ADDENDUM 1 – JOB 31

TO: All prospective bidders on Projects SOIB-NH-7-085(110)127, Job No. 31 scheduled for the November 13, 2020 bid opening.

PLAN ADDENDUM SUMMARY AND APPROVAL

PROJECT INFORMATION		
Project:	SOIB-NH-7-085(110)127	PCN: 22304
Location:	Horseshoe Bend Slide Repair – North of Long X Bridge	
Date:	11/03/2020	Lead Designer: Jeff Rensch
Bid Opening Date:	11/13/20	JOB#: 31 Addendum#: 1

Revised	11/2/20	STATE	PROJECT NO.	PCN	SECTION NO.	SHEET NO.
		ND	SOIB-NH-7-085(110)127	22304	1	1

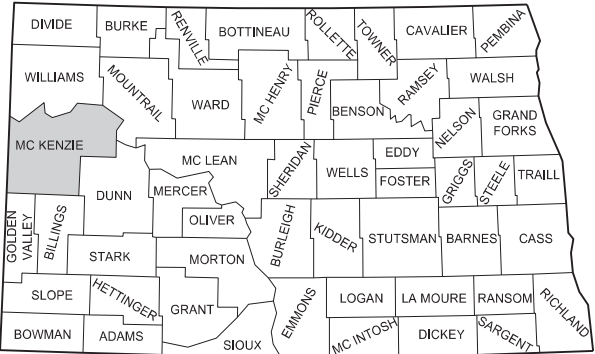
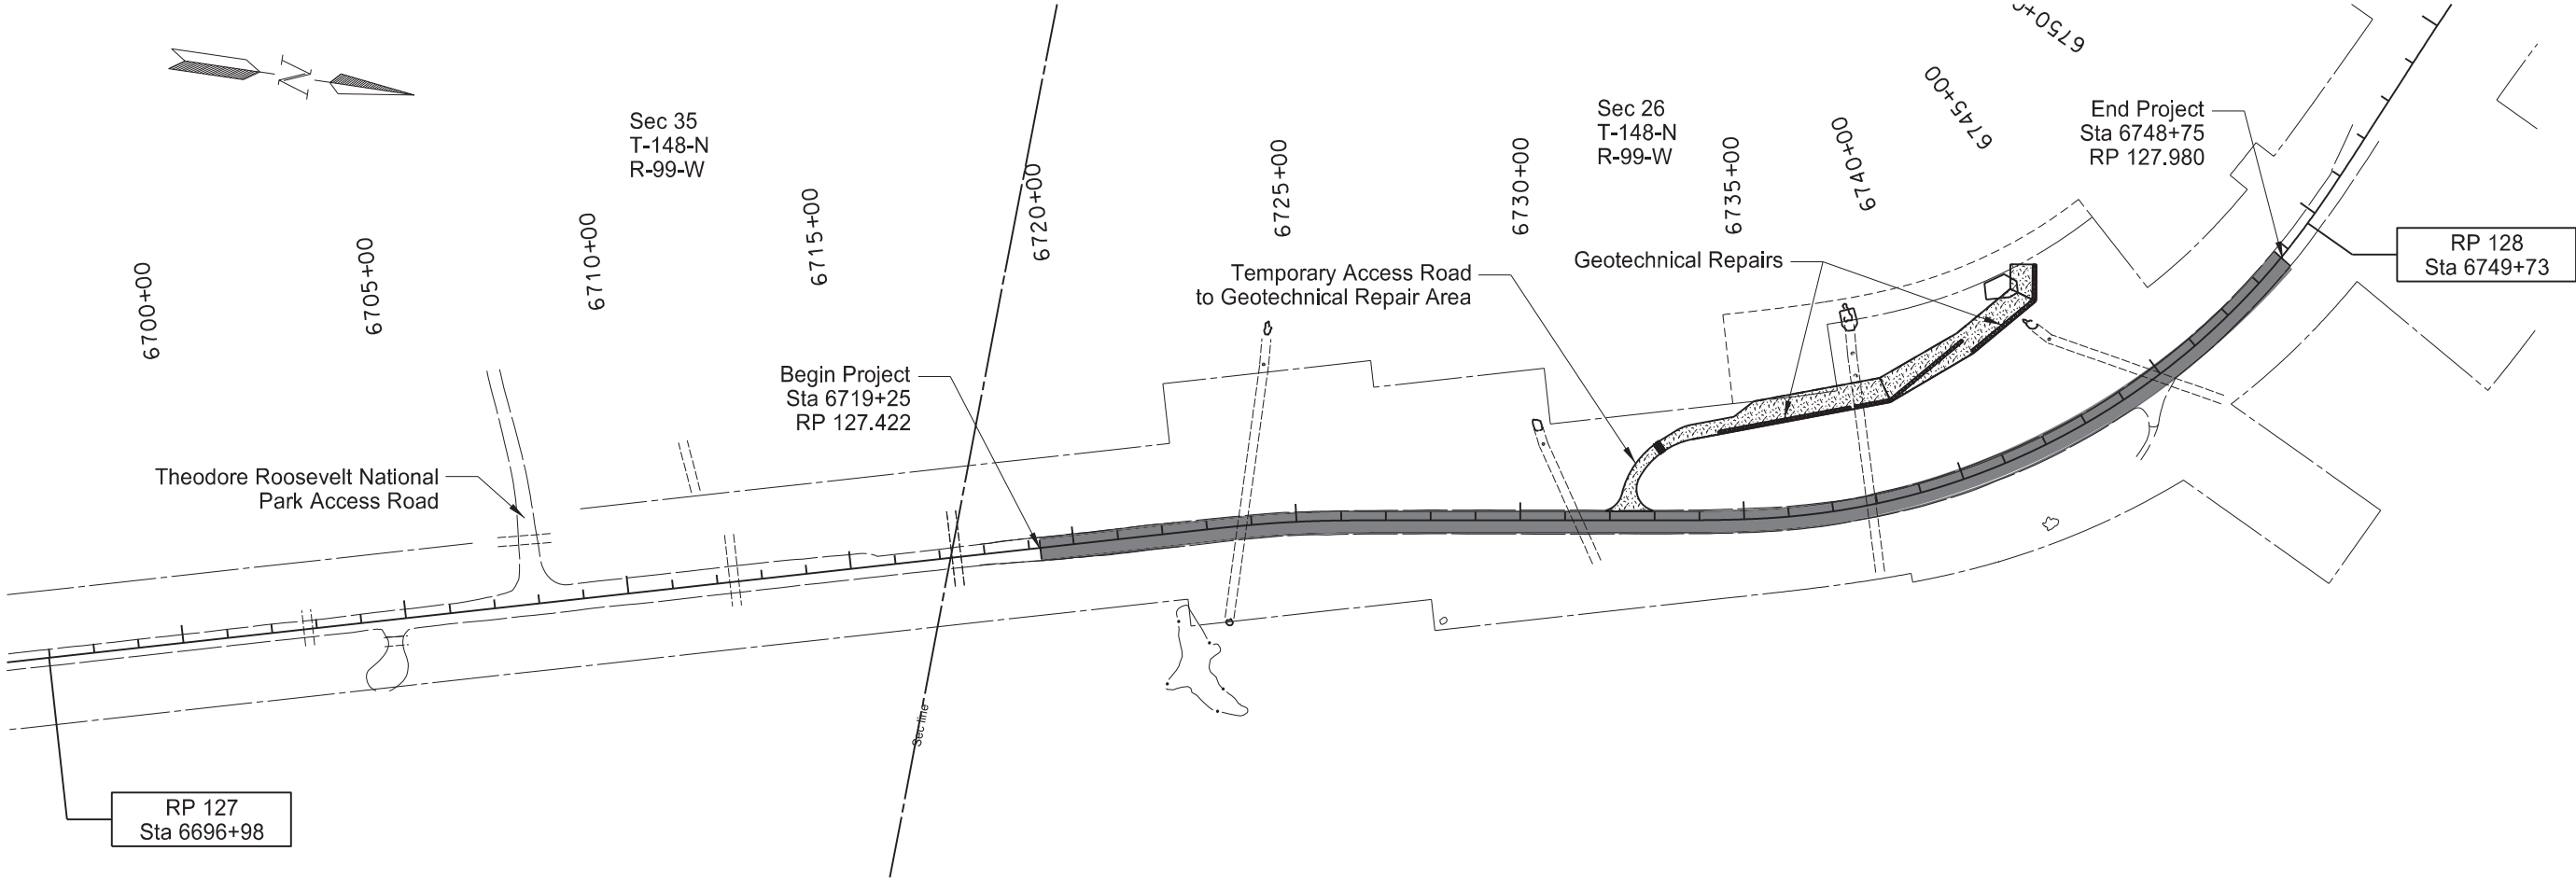
PLAN SHEET CHANGES		
Section	Sheet	Description of Change
001	1	Eliminated Temp Easement east of US 85 & part of Temp Easement west of US 85.
004	1 & 2	Eliminated Temp Easement east of US 85 & part of Temp Easement west of US 85. Modified Limits of Disturbance Line. Changed width of Temp Access Road and Temp Work Road prior to Station 21+50.
006	5	Eliminated Note 752-P01 TEMPORARY FENCE. Renumbered Note 752-P02 NATIONAL PARK SERVICE (NPS) FENCING to Note 752-P01.
008	1, 2, & 3	Changed quantities for multiple items. Eliminated bid item for Temporary Fence. Added bid item for Corner Assembly Barbed Wire.
010	2	Changed earthwork quantities
030	1 & 2	Changed widths of Typical Sections shown on sheets.
060	1, 2, & 6	Eliminated part of Temp Easement west of US 85. Modified Limits of Disturbance Line. Changed width of Temp Access Road and Temp Work Road prior to Station 21+50. Changed quantities of Traffic Service Aggregate.

Revised	11/2/20	STATE	PROJECT NO.	SECTION NO.	SHEET NO.
		ND	SOIB-NH-7-085(110)127	70	1

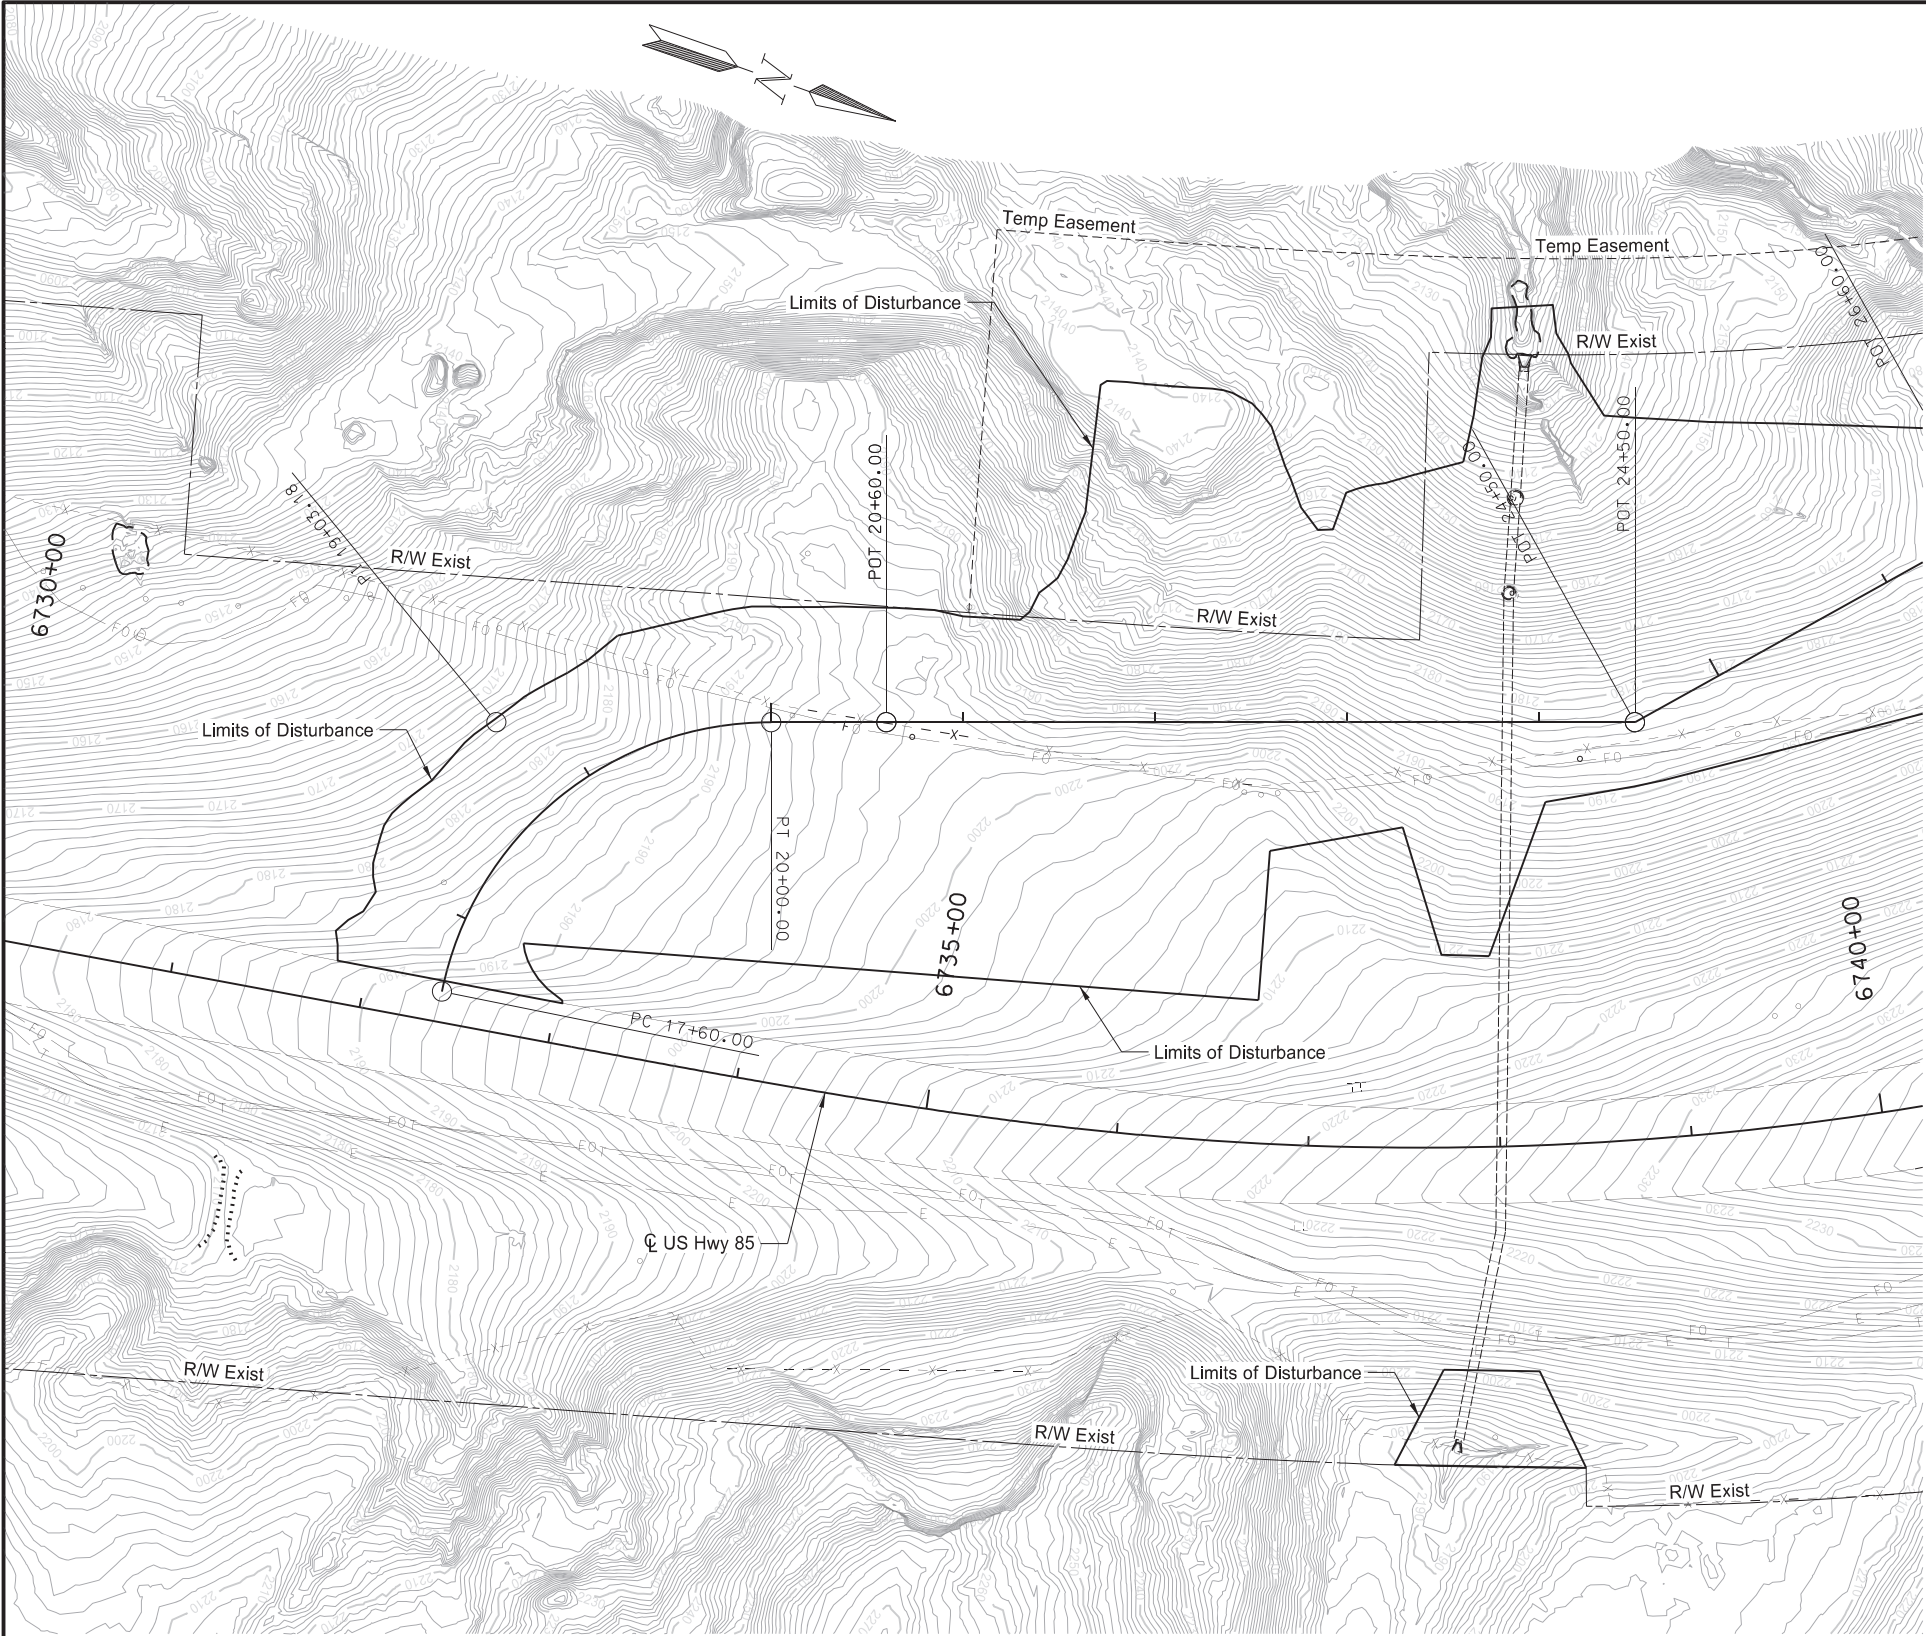
070	1 & 3	Eliminated Temp Easement east of US 85 & part of Temp Easement west of US 85. Modified Limits of Disturbance Line.
075	2	Eliminated Temp Easement east of US 85 & part of Temp Easement west of US 85. Modified Limits of Disturbance Line.
076	1 & 4	Eliminated Temp Easement east of US 85 & part of Temp Easement west of US 85. Modified Limits of Disturbance Line. Changed width of Temp Access Road and Temp Work Road prior to Station 21+50. Changed quantities of Temporary Cover Crop and Bonded Fiber Matrix.
077	1	Eliminated Temp Easement east of US 85 & part of Temp Easement west of US 85. Modified Limits of Disturbance Line. Changed quantities of Topsoil, Seeding Class III, Bonded Fiber Matrix, and ECB Type 3.
080	1 & 2	Eliminated Temp Easement east of US 85 & part of Temp Easement west of US 85. Modified Limits of Disturbance Line. Modified fencing east of US 85. Removed pay item for Temporary Fence. Added pay item for Corner Assembly Barbed Wire. Changed quantity of Remove Existing Fence and Fence Barbed Wire 4 Strand.

Revised	11/2/20	STATE	PROJECT NO.	SECTION NO.	SHEET NO.
		ND	SOIB-NH-7-085(110)127	100	4

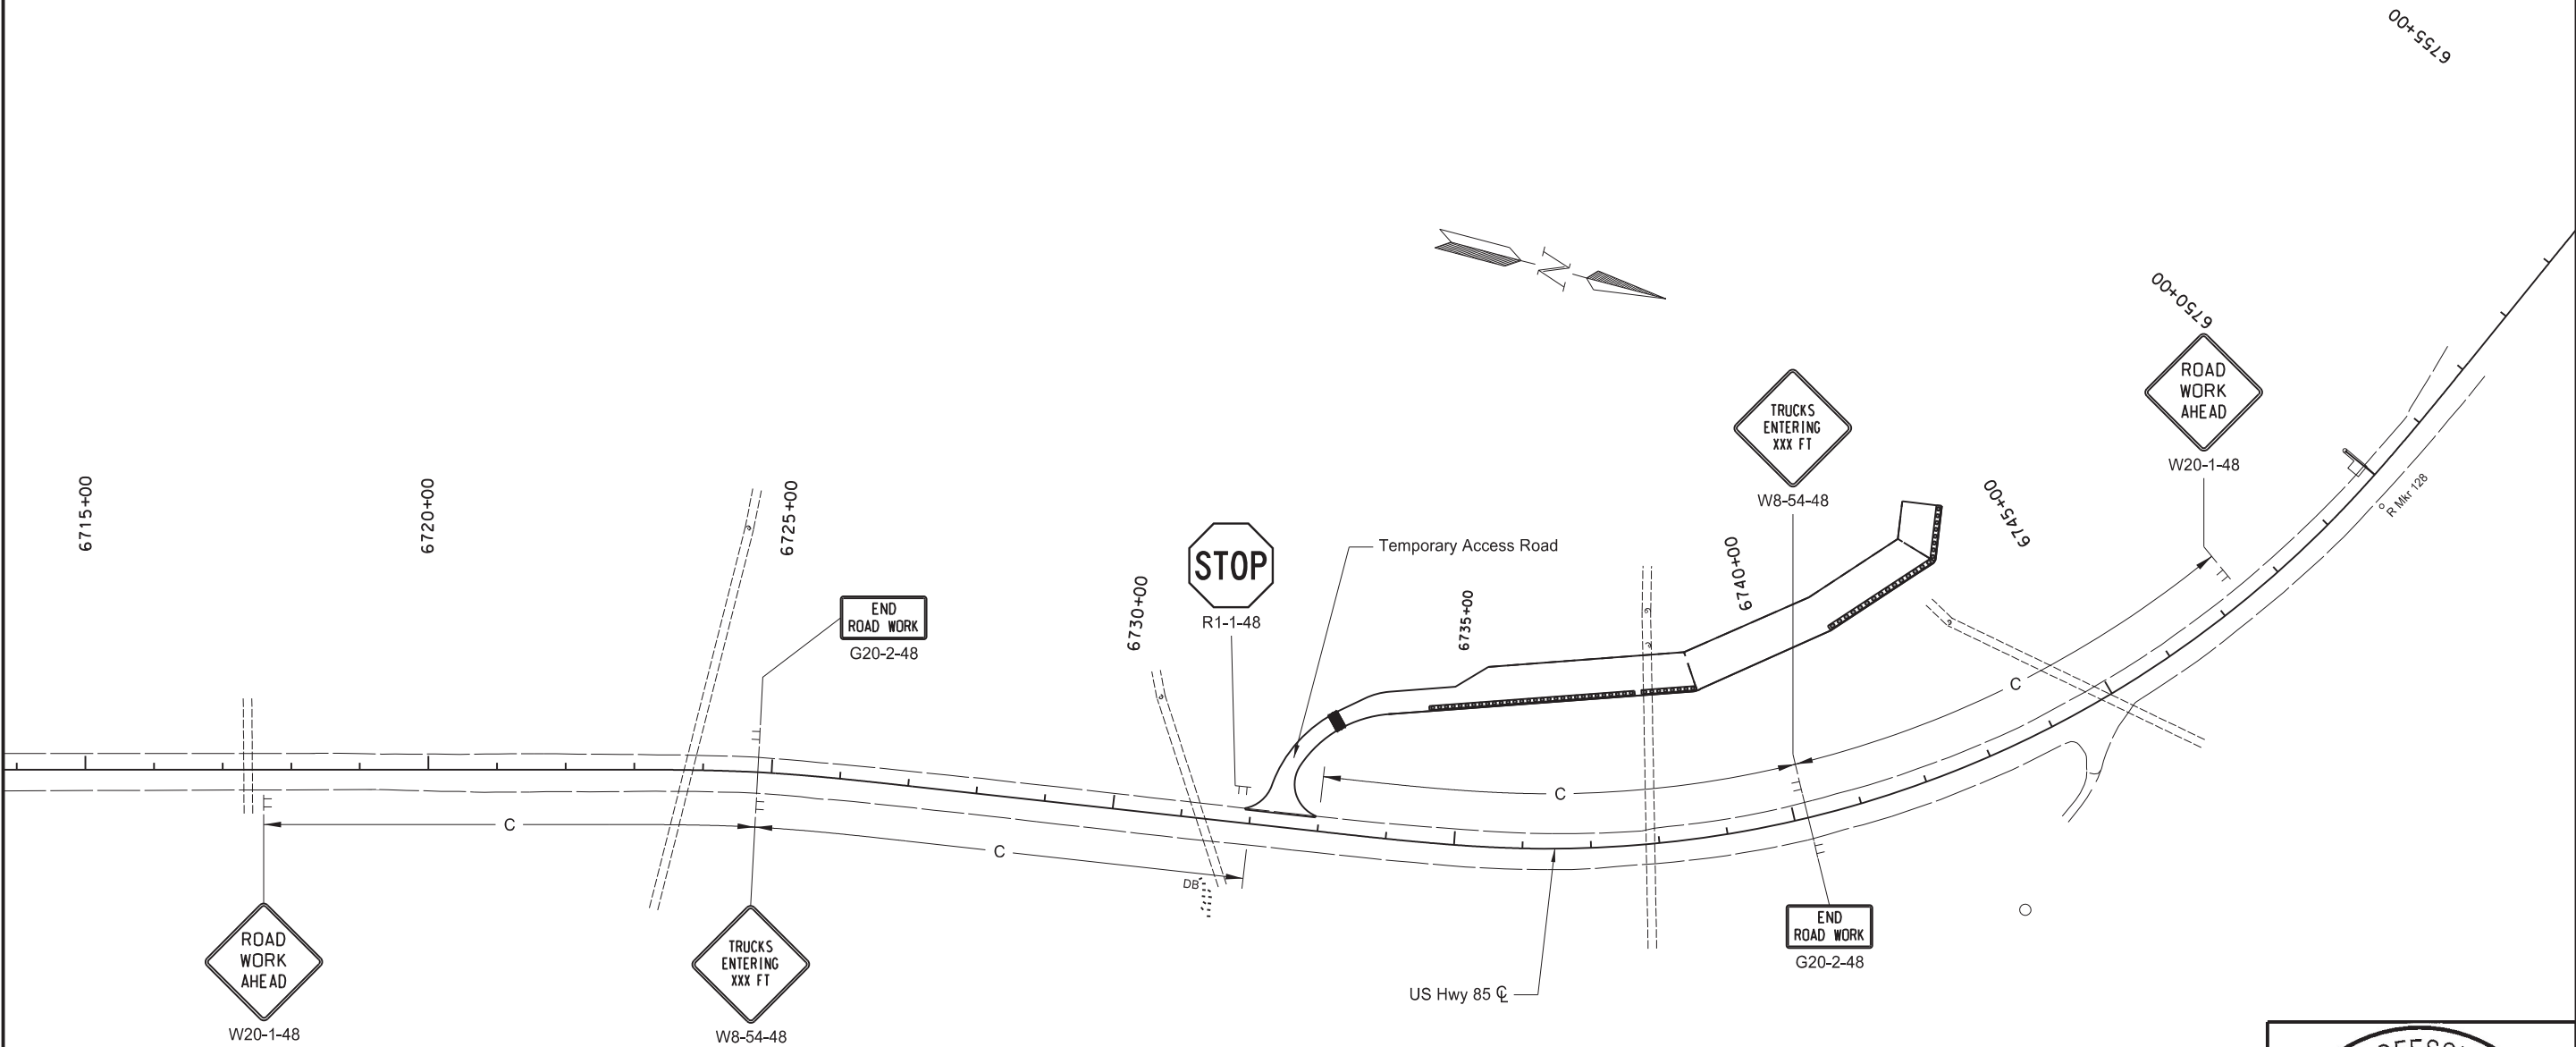
100	4	Changed width of Temp Access Road and Temp Work Road prior to Station 21+50.
200	1 - 21	Changed cross sections to reflect changes to width of Temp Work Road and modified Limits of Disturbance. Changed Earthwork End Areas.
200	62 – 79	Changed cross sections to reflect changes to width of Temp Work Road and modified Limits of Disturbance. Changed Earthwork End Areas.
Supplemental Design Data		Supplemental Design Data was modified to reflect changes to the width of the Temp Access Road and the Temp Work Platform and the changes to the limits of disturbance.
